Declaration of Differences Letter

Modules CYBT-333047-02 AND CYBT-333032-02 have the same PCB, Bluetooth chip, periphery parts and the encapsulation of the main chip.

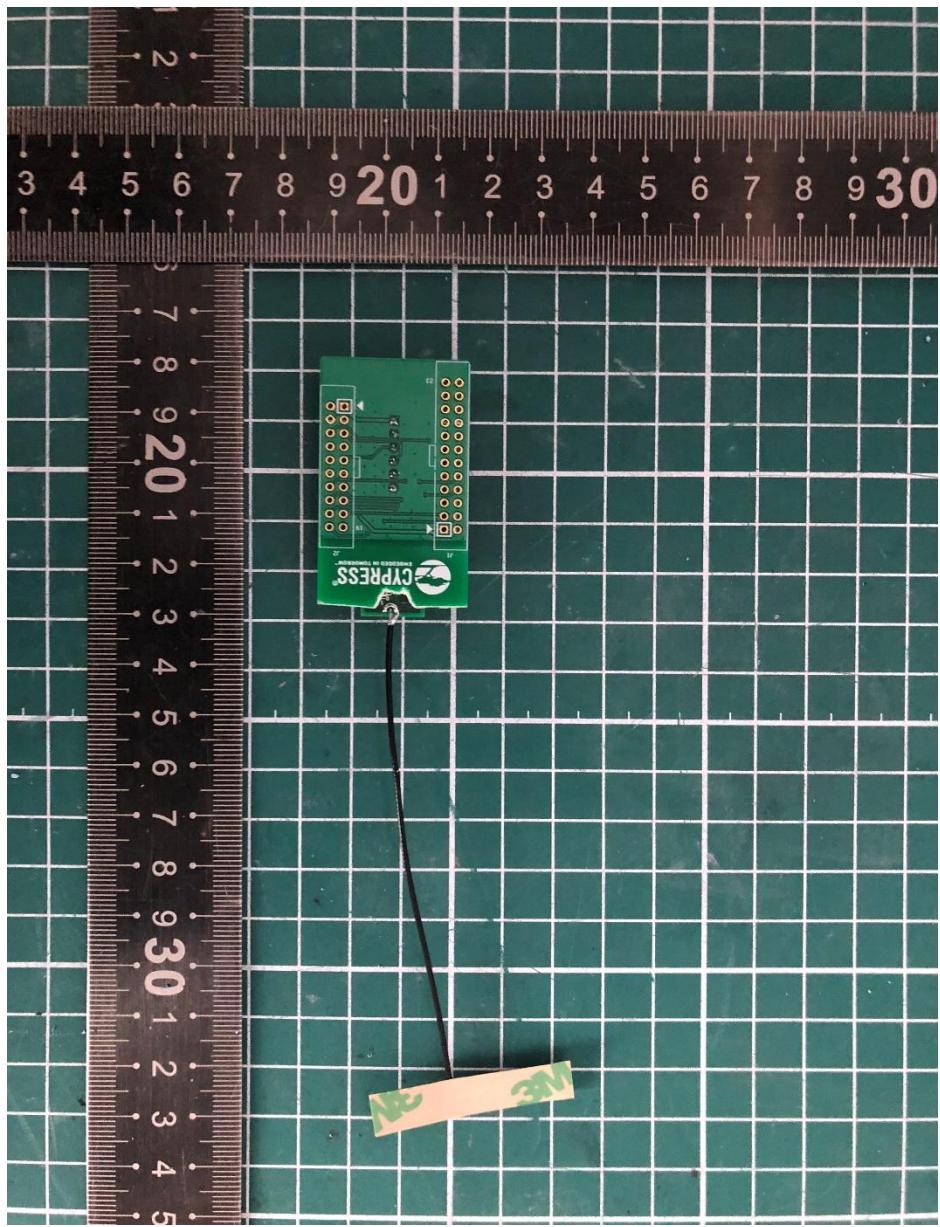
The difference is the configuration of antenna:

- CYBT-333032-02, RF path is configured with external antenna via RF pin

- CYBT-333047-02, RF path is configured with external dipole antenna via UFL connector, details is as below:
